SUBJECT: 25-040 Loaf Land Subdivision - Comment Response

Thank you for your continued review of the Subdivision Application Permit (SP 4103) for Loaf Land Subdivision in Coplin Plt.. The team recently received the additional review comments from LUPC in regard to this application, dated August 27, 2026. These comments can be seen below in *italic*, followed by Main-Land's response in regular typeset. Updated or amended exhibits have been provided as attachments.

“LOAF LAND SUBDIVISION” AT MOUNTAIN ROAD, COPLIN PLANTATION, MAINE

**STREAM PLAN &
PROFILE**

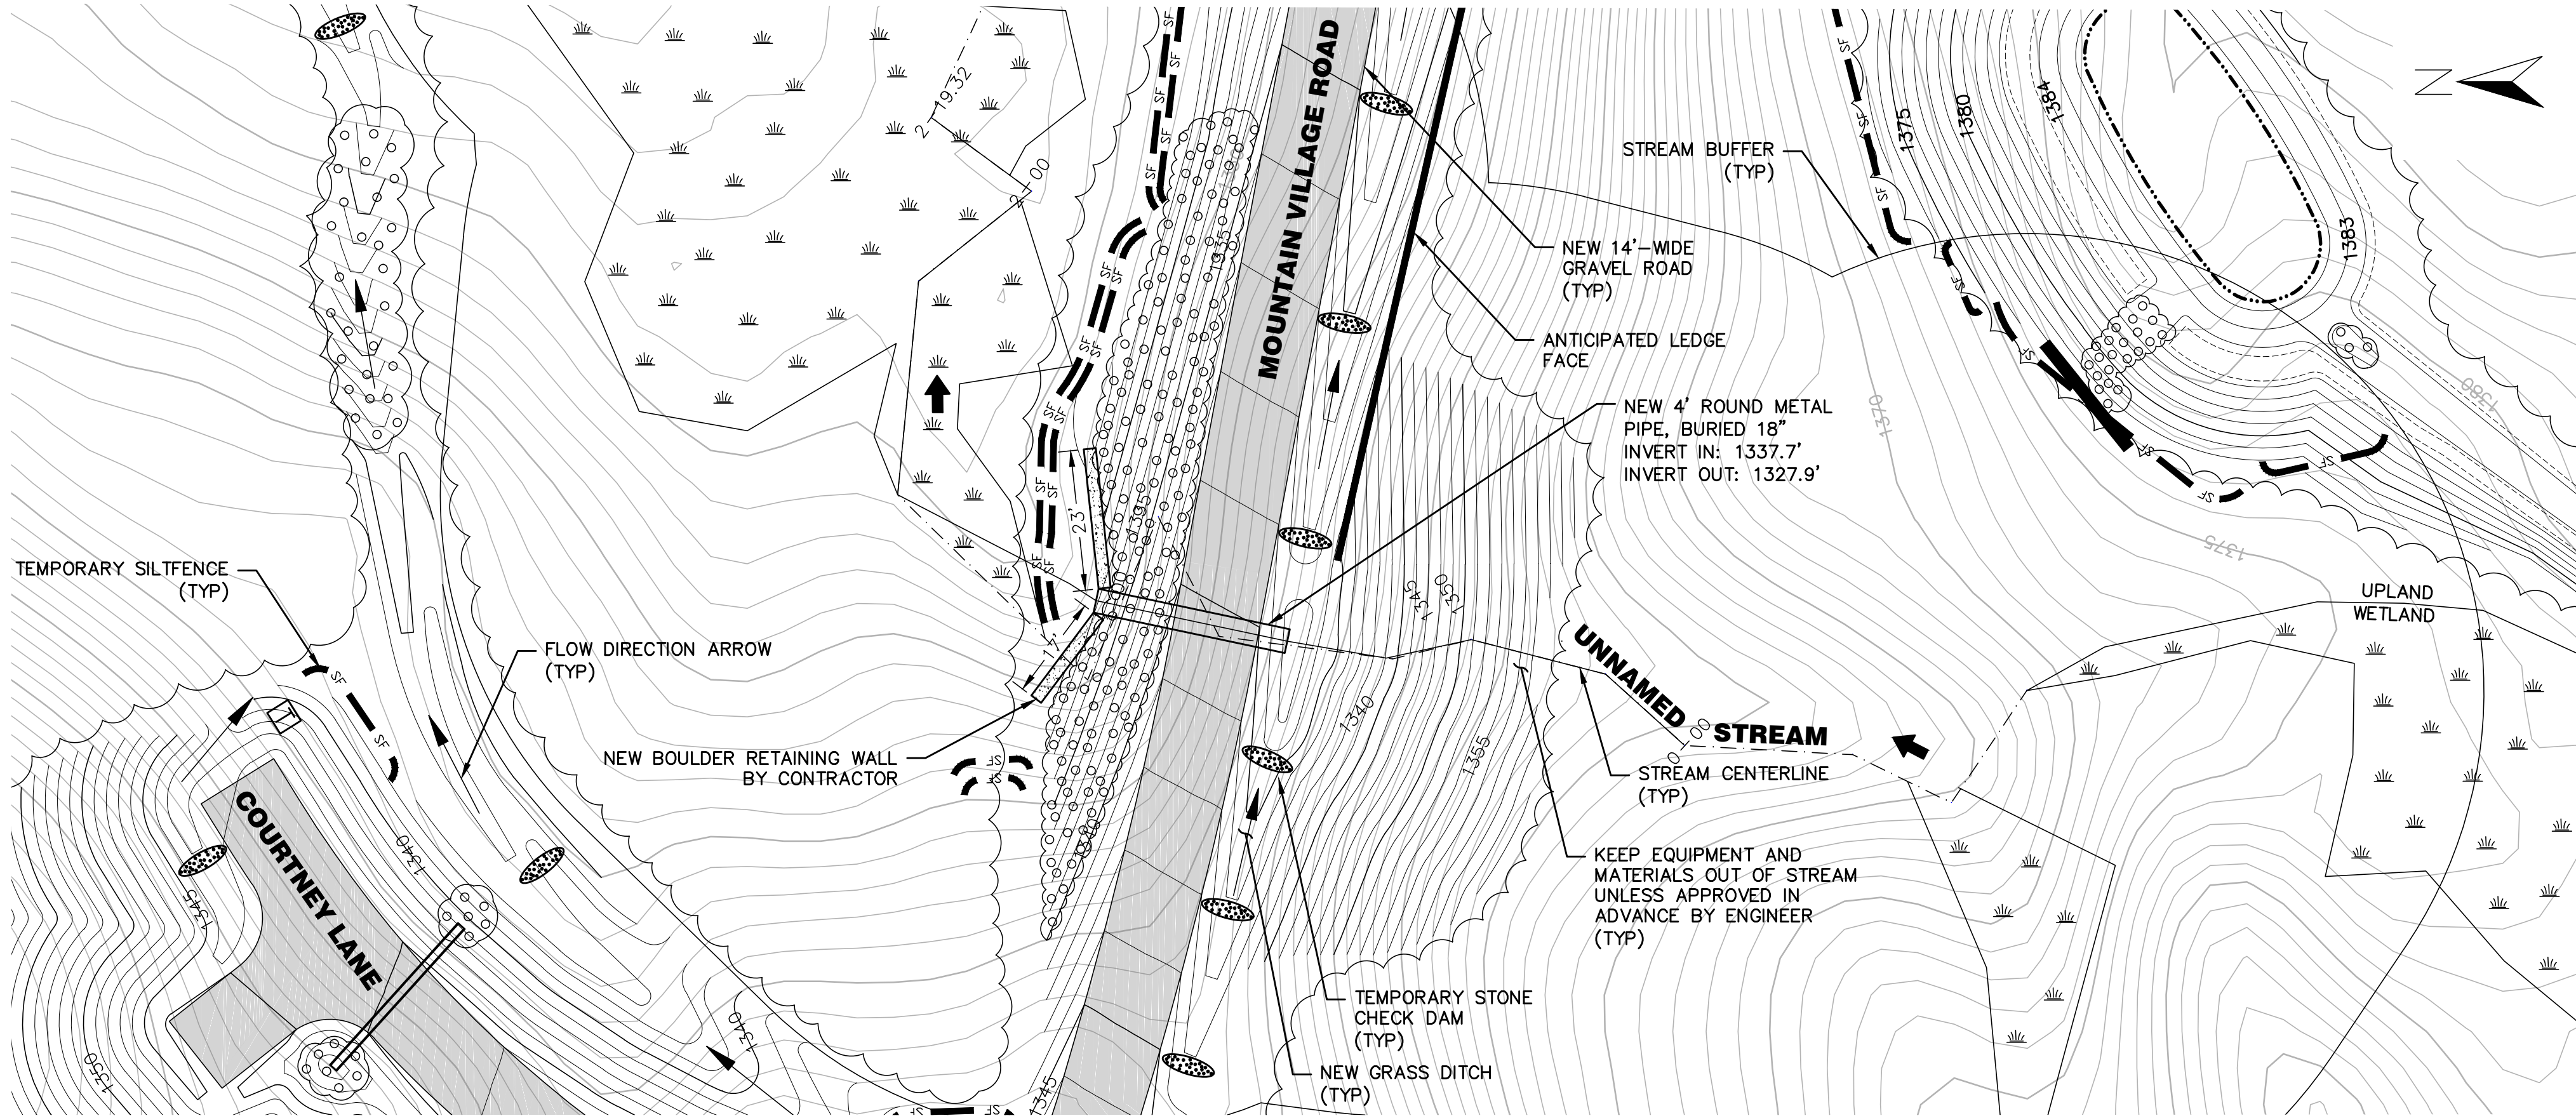
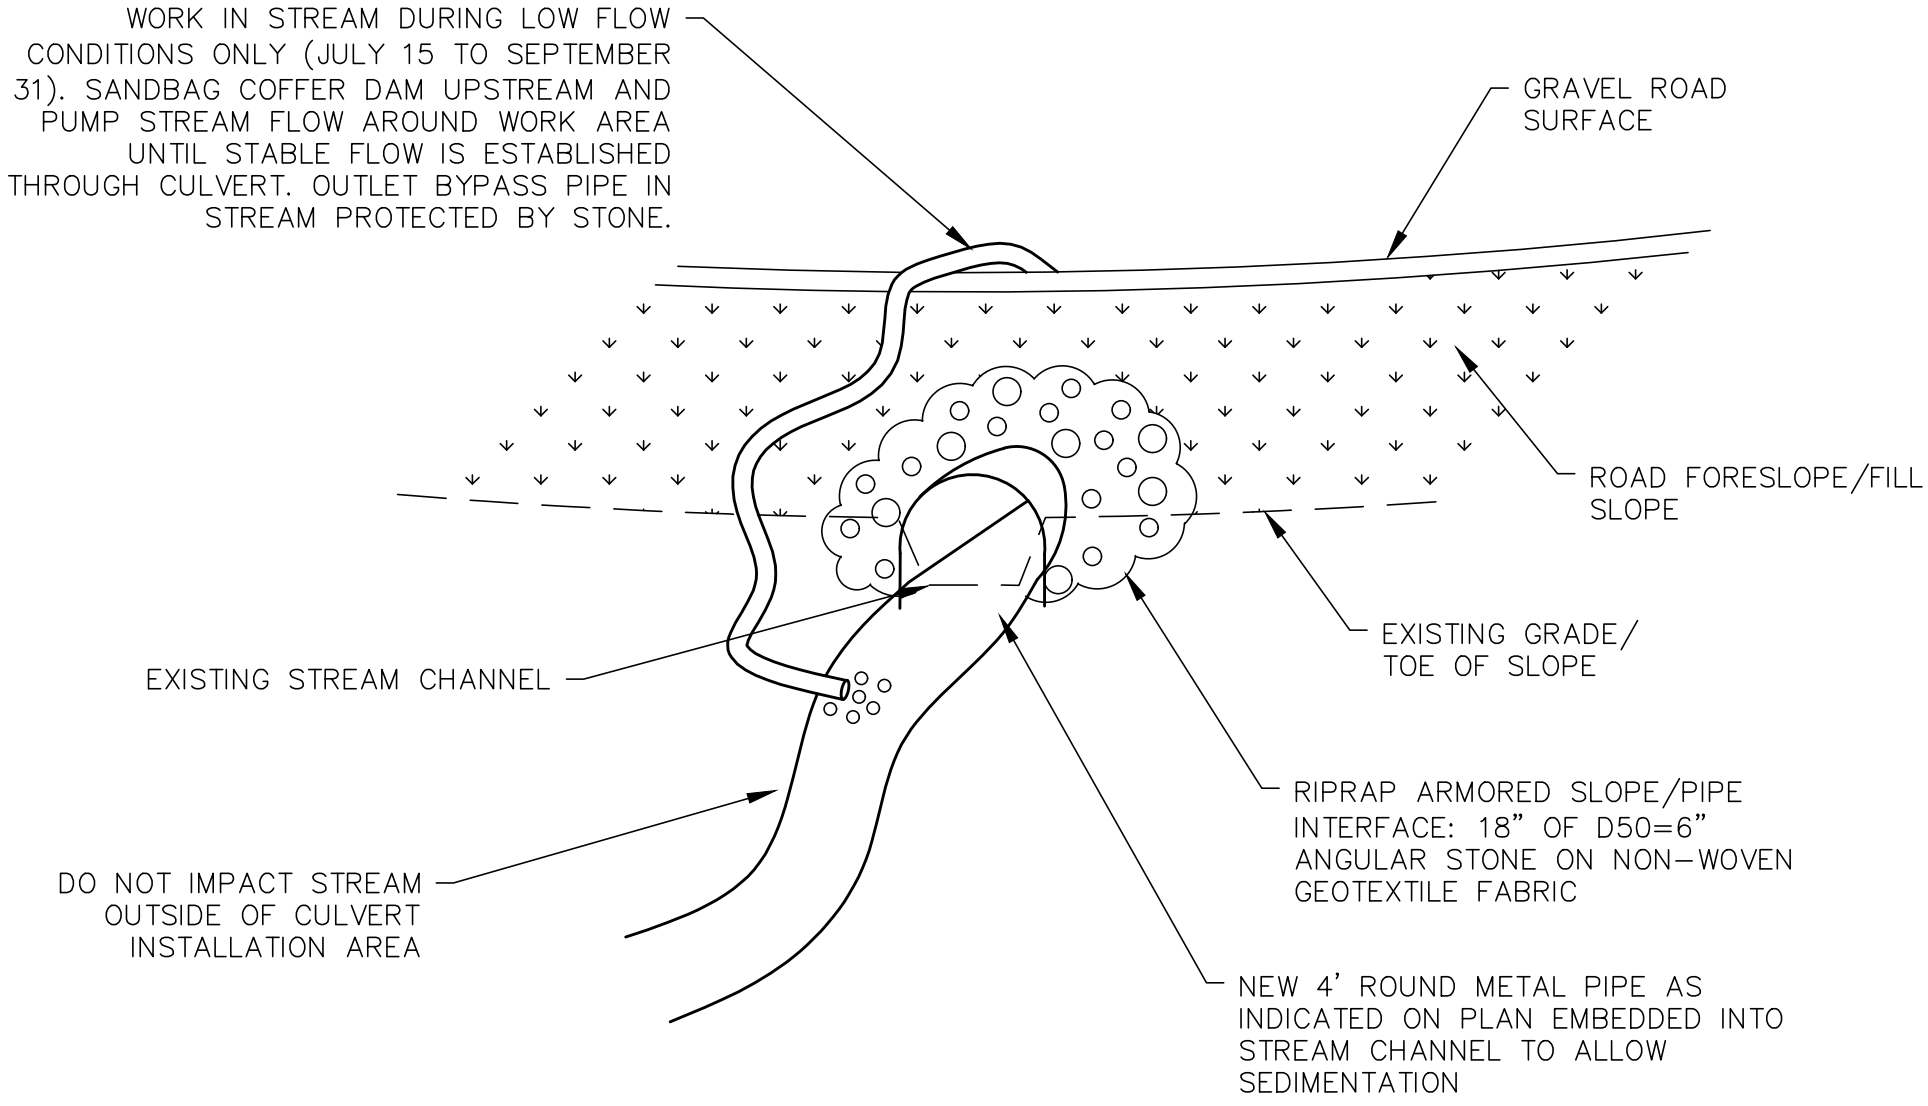
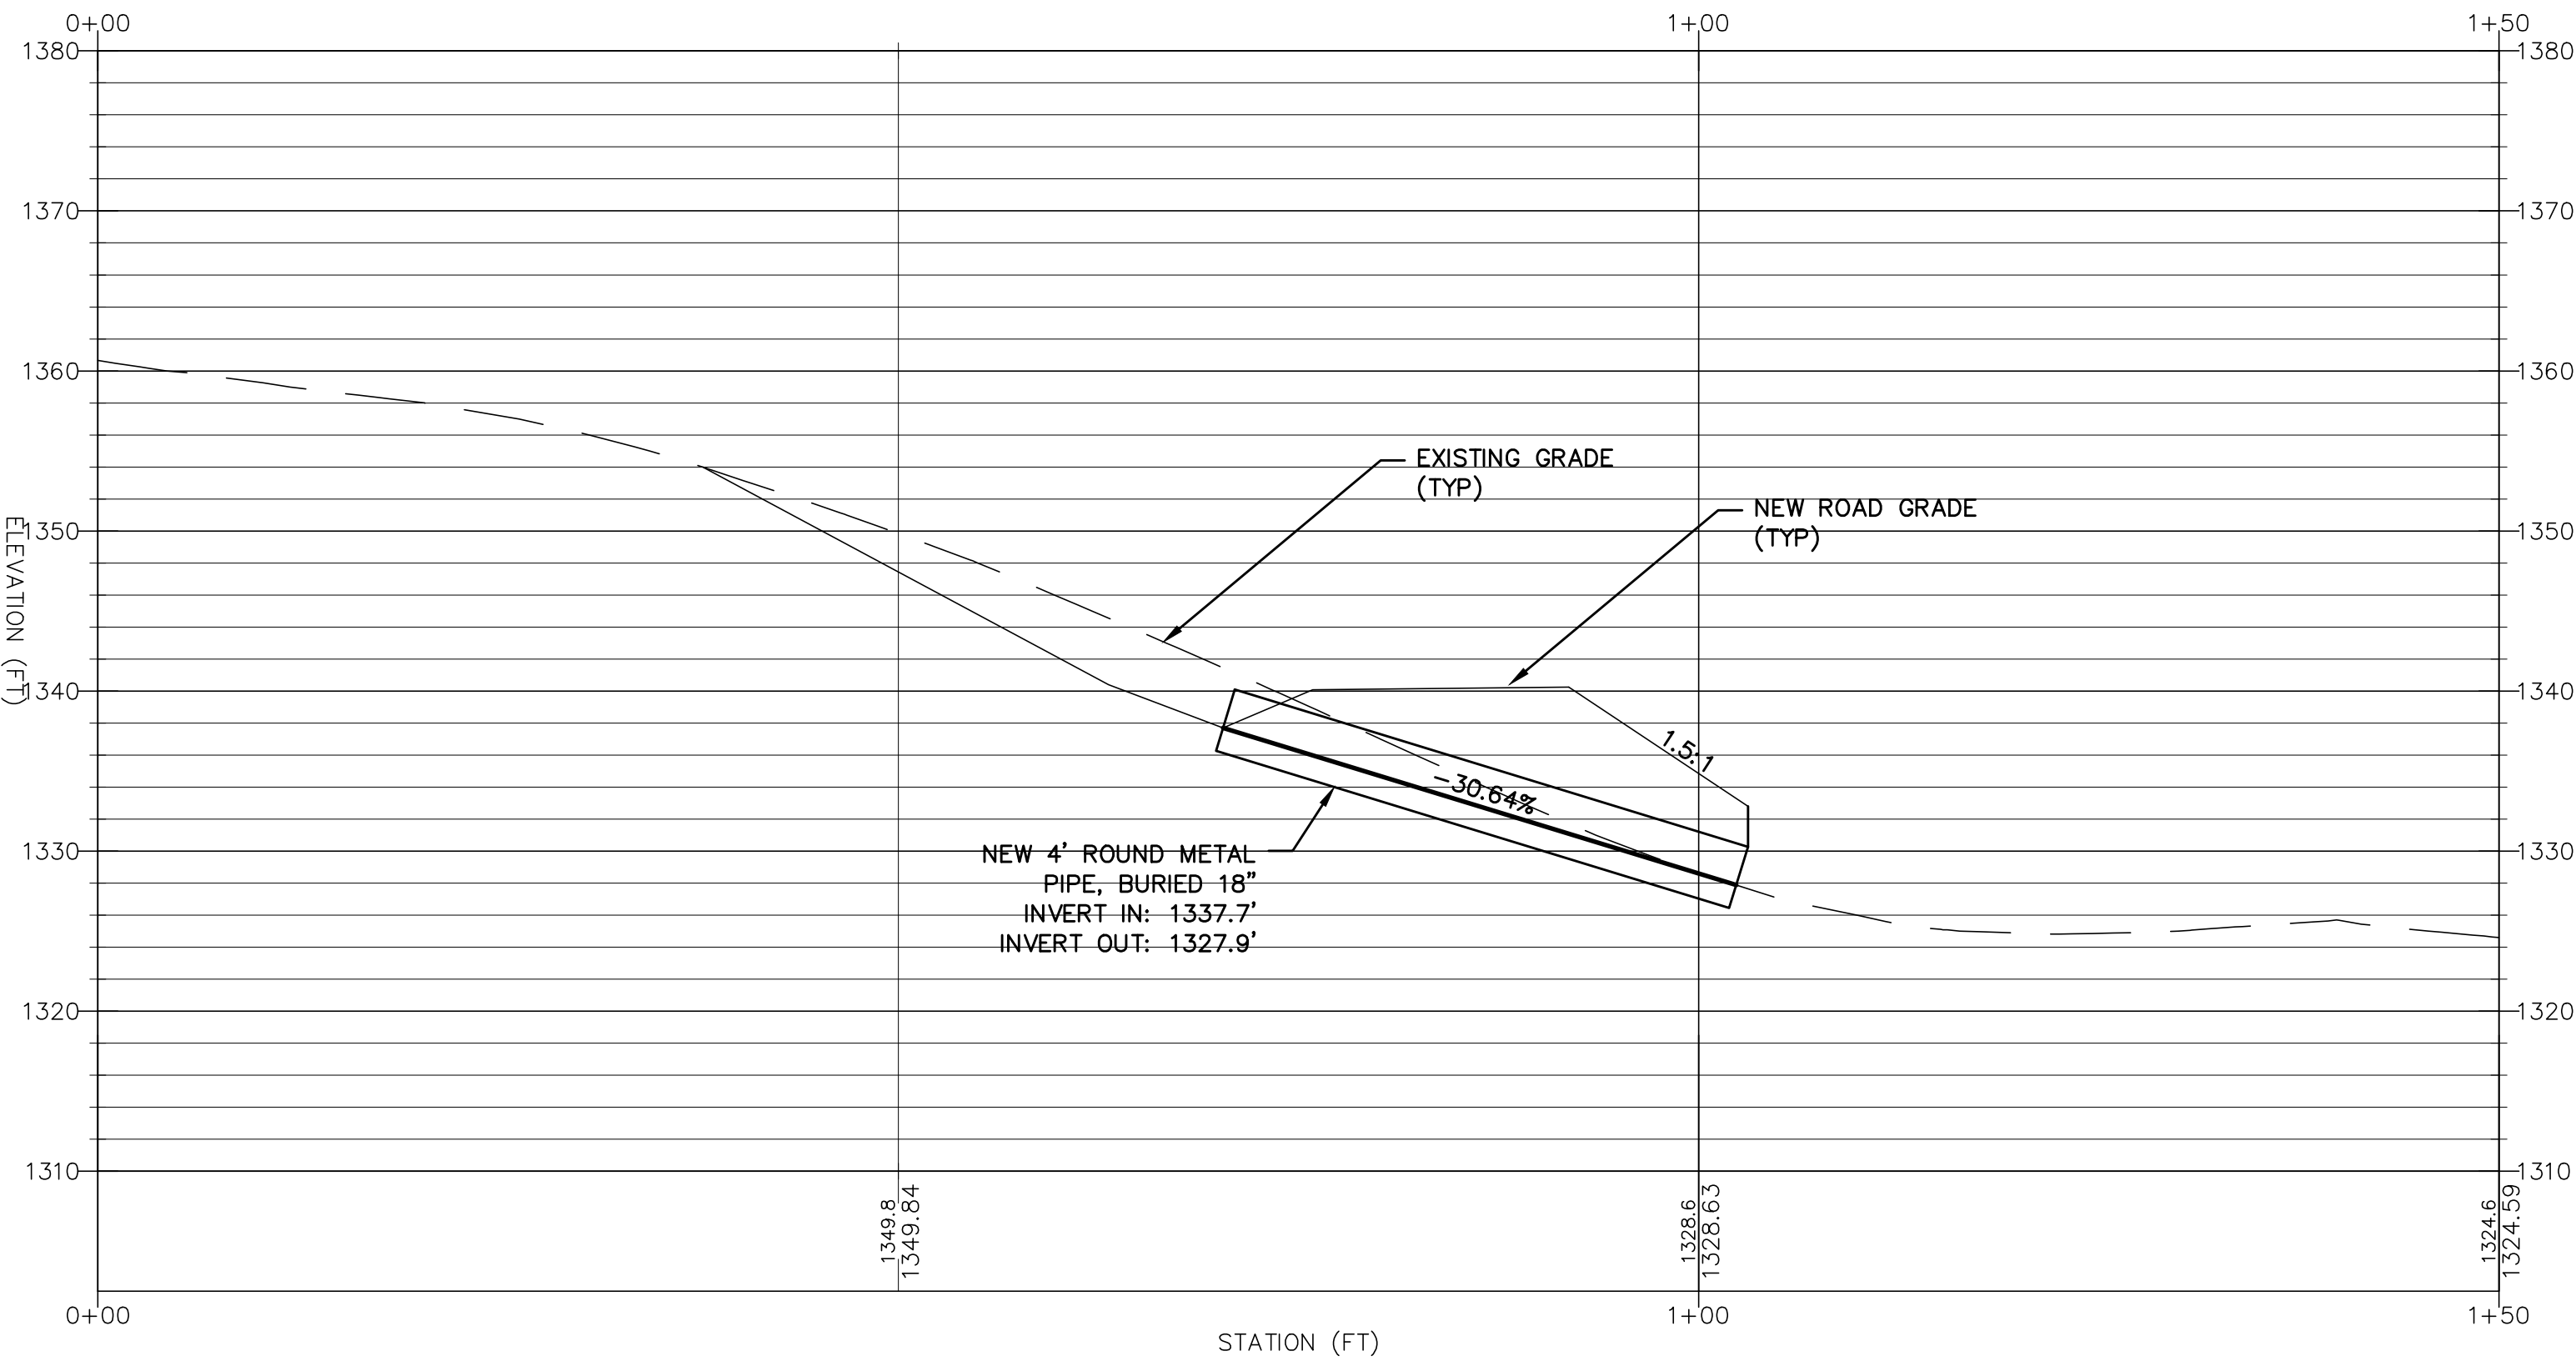
- *On Plan C5.3 (Stream Plan & Profile), clarify the design of the wingwall and how wetland impacts will be avoided during construction (see Sebago Technics review comment IV.11 on Sheet C5.3).*
 - *Sebago Response: The stream profile appears to indicate the need for a 7 foot-tall wing wall on the outlet side. The plans should better depict the design intent of this wingwall and how wetland impacts will be avoided during its construction. Silt fence is also shown through the wetland in this area with no stated wetland impact in this area. Additionally, the design plans include lengths of side slopes that are at 2H:1V or steeper. It should be shown on the grading plan which slope stabilizing measures are to be used and their extents where the side slope exceeds 3H:1V.*

The design plans have been updated accordingly. The wing wall design has been reduced to consist of a 4' wall, an acceptable height for a boulder wall installation by the contractor. The

siltfence and grading has been adjusted to provide more clearance adjacent to wetland. Lastly, the steeper sections have been indicated on C3.1 Grading Plan.

Image 1: Potential area that the project may be visual based on USGS Topographic Map

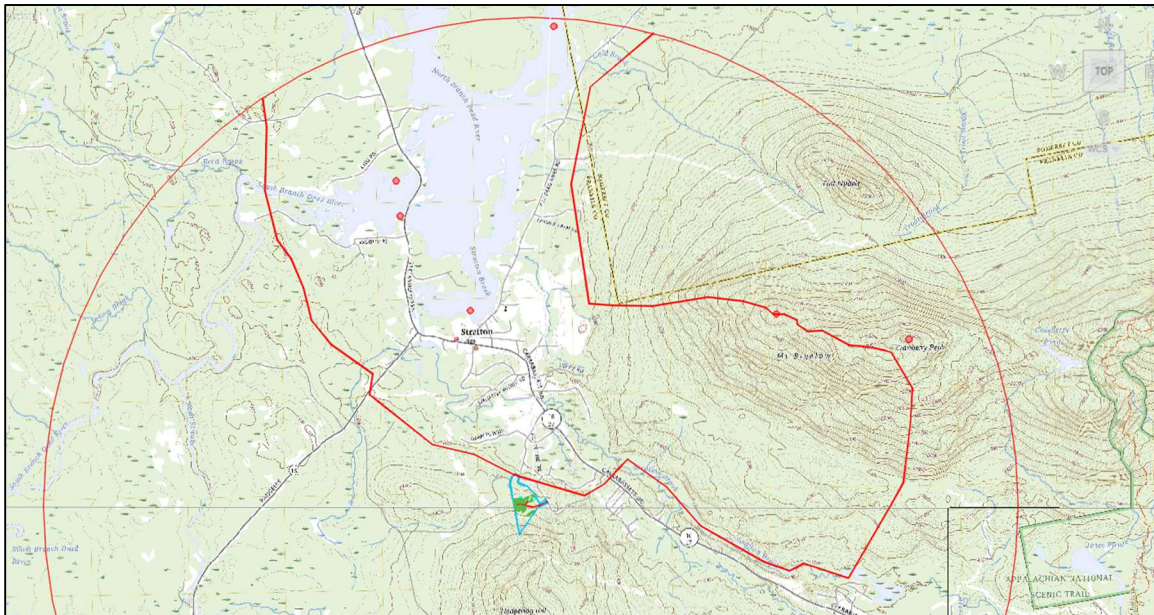
- *Harmonious Fit and Natural Character (Ex. 24)*
 - *Provide the methods for determining the viewshed depicted in Image 1 (p. 104).*

The narrative in Exhibit 24 has been updated to encompass this comment.
